## FINAL DRAINAGE REPORT

**LOT 2 ELM GROVE VILLA SUBDIVISION  
SMITH PLUMBING & HEATING  
PCD Filing No.: PPR2143**

*PCD Filing No. PPR2143*

WQ PLAN

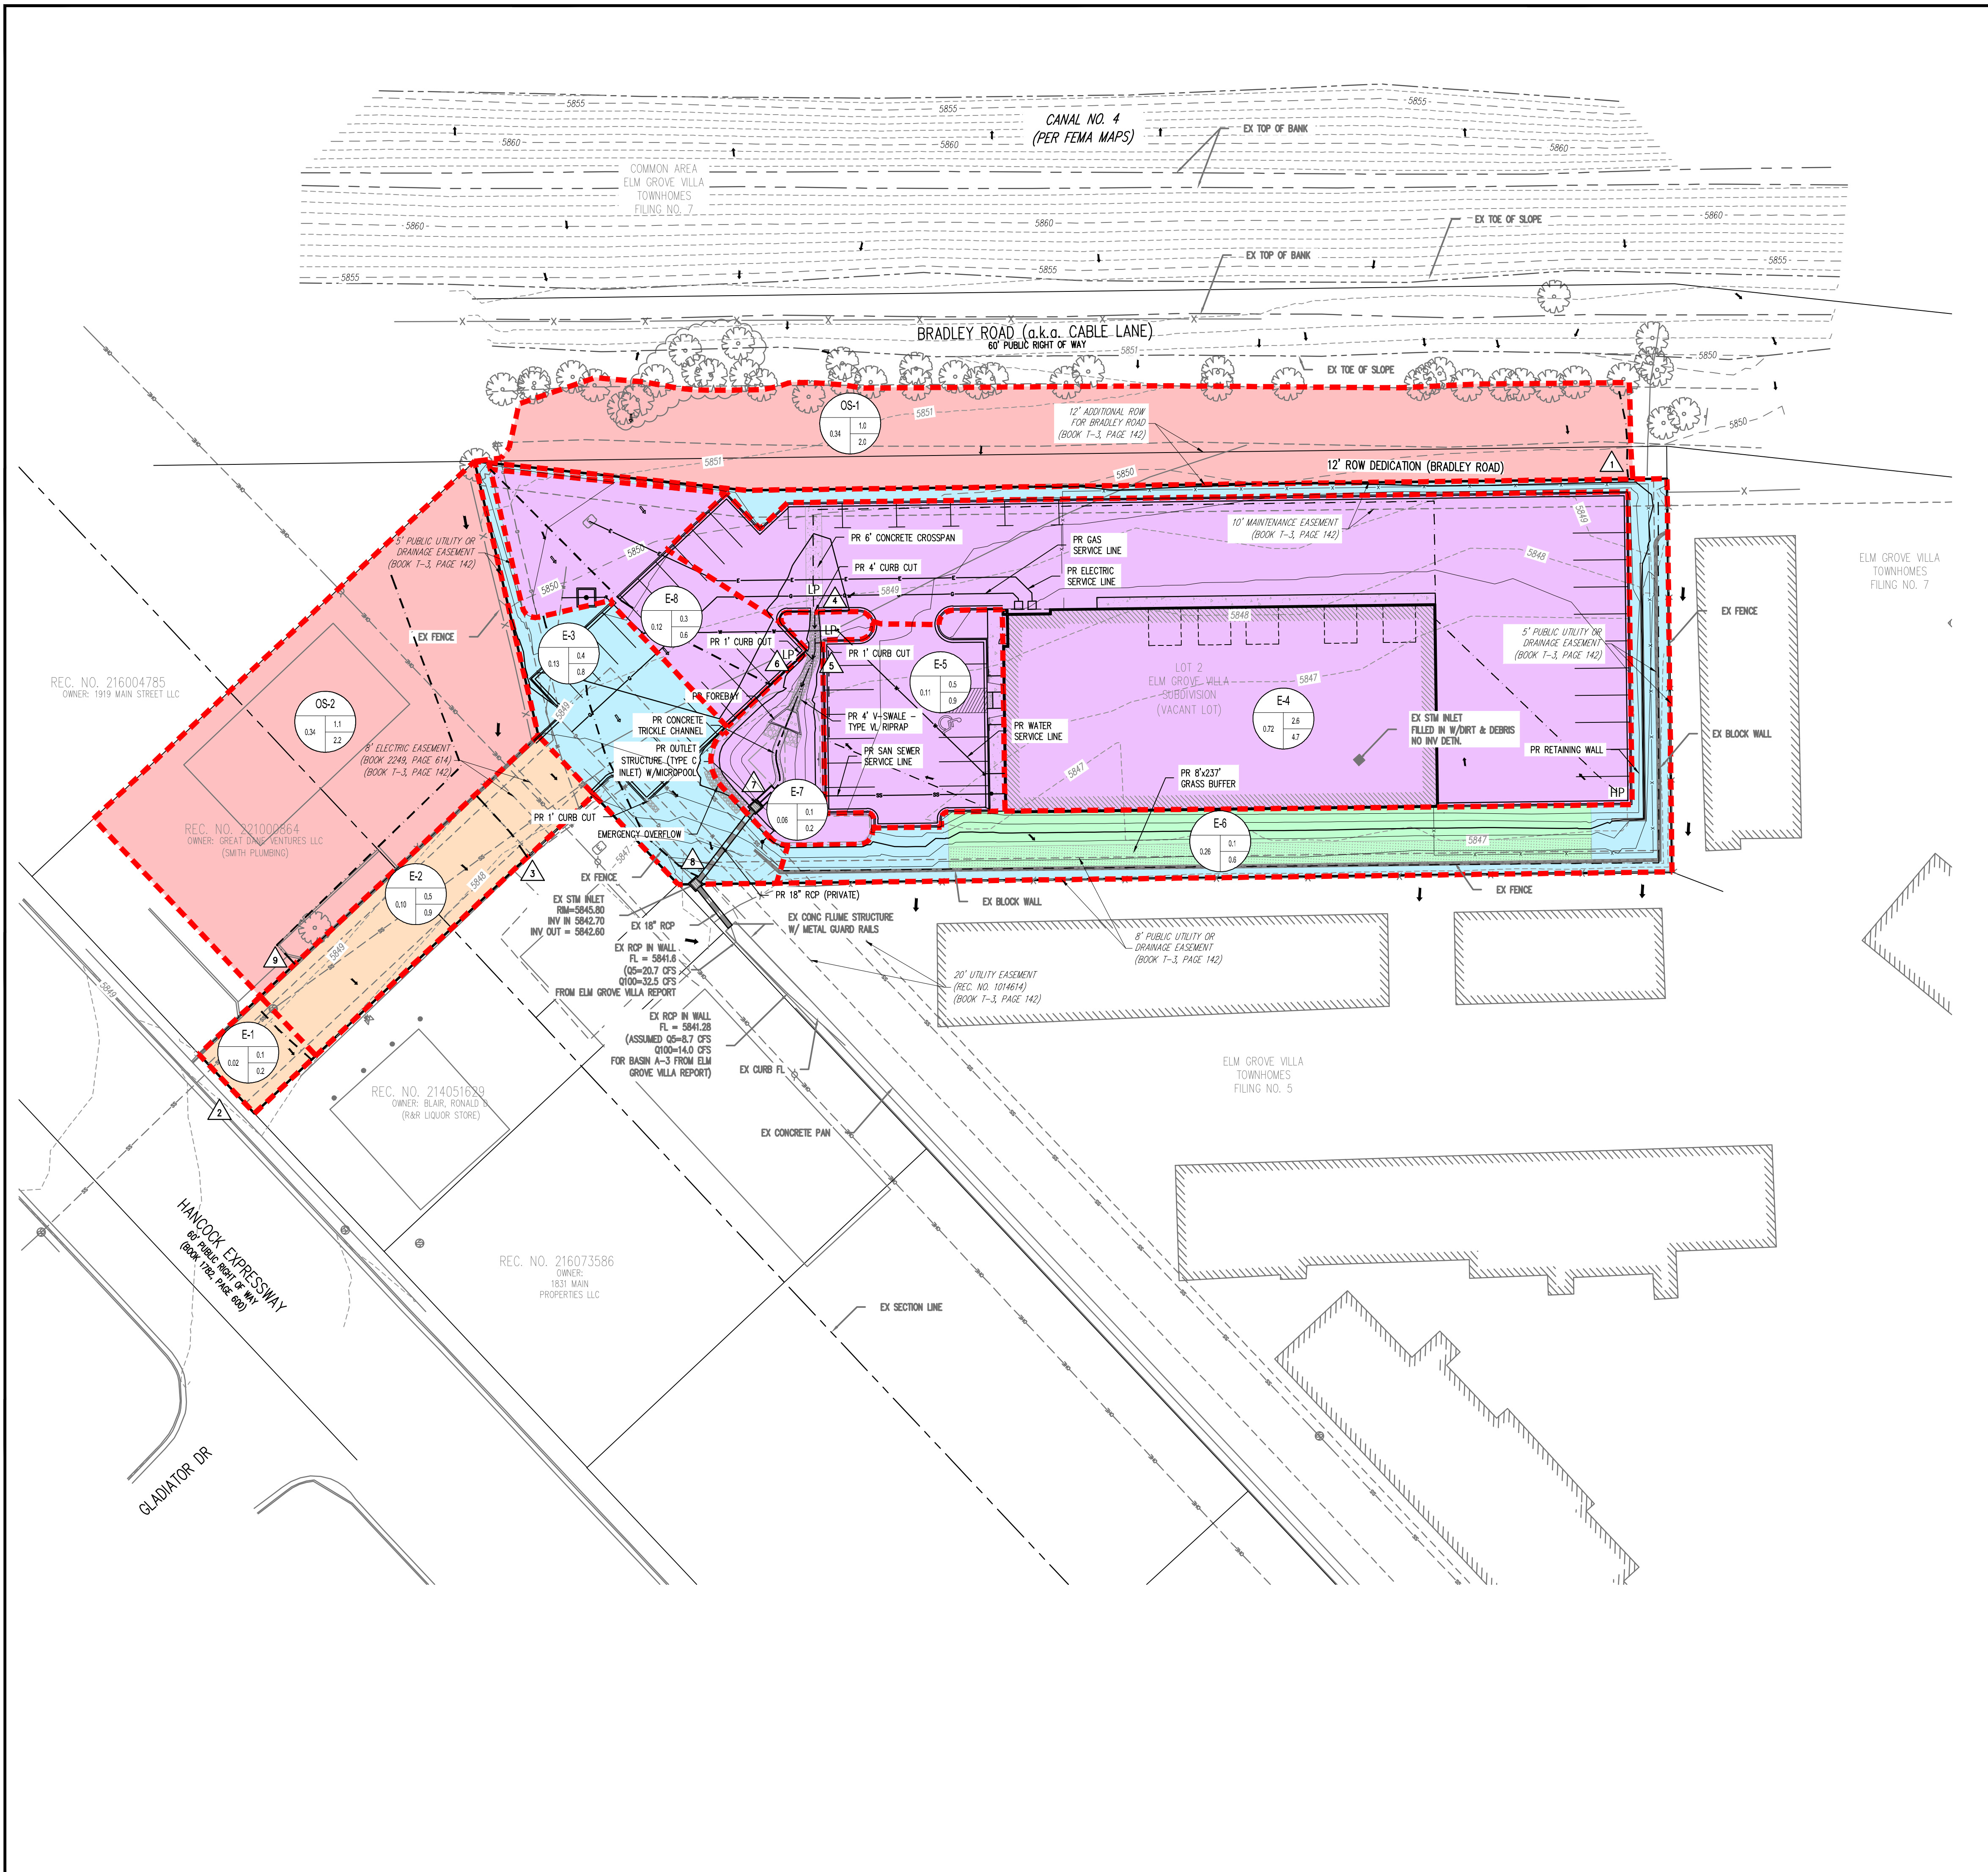
From field observations, the flow exiting the 6' concrete pan is not directed or funneled sufficiently to the curb chase. A suitable conveyance should be implemented to direct flow to concrete chase. See pdf pg 25 below.
